M.I.L "ON" DTC P2195, P2197, P0138, P0158, P0171, P0174, P0031, or P0051

Service Category Engine/Hybrid System

Section Engine Control

YEAR(S)	MODEL(S)	ADDITIONAL INFORMATION
2005 – 2007	Avalon	
2007 – 2008	Camry

- (2) Uniformly loosen and remove the 6 nuts. **Figure 1.**

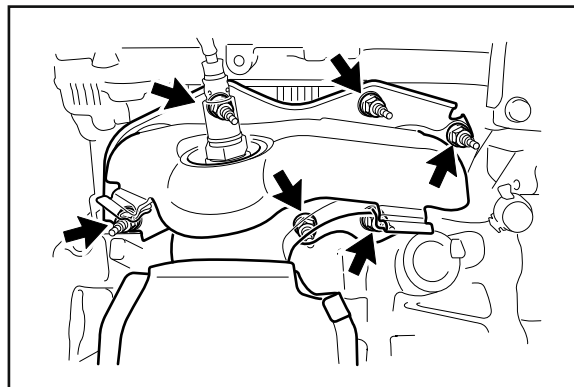
B. Bank 1 (RH) Exhaust Manifold Sub-assembly:

- Disconnect the air fuel ratio sensor connector clamp.

Figure 2.

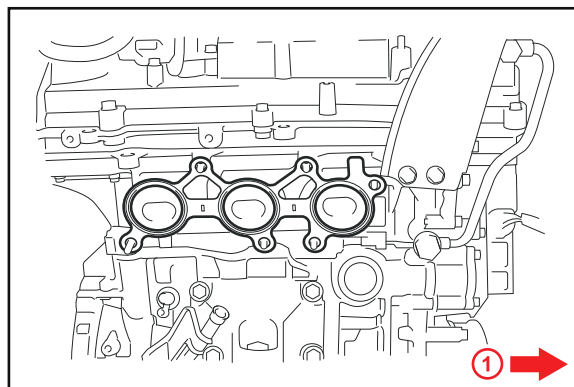
- (3) Remove the manifold and gasket.
- (4) Install a NEW gasket as shown.

- (5) Install the NEW exhaust manifold sub-assembly RH with the 6 nuts and reassemble in reverse order.

The revised A/F sensor is not compatible with the previous A/F sensors or previous Bank 1 (RH) exhaust manifold.

Torque: 21 N*m (214 kgf*cm, 15 ft*lb)
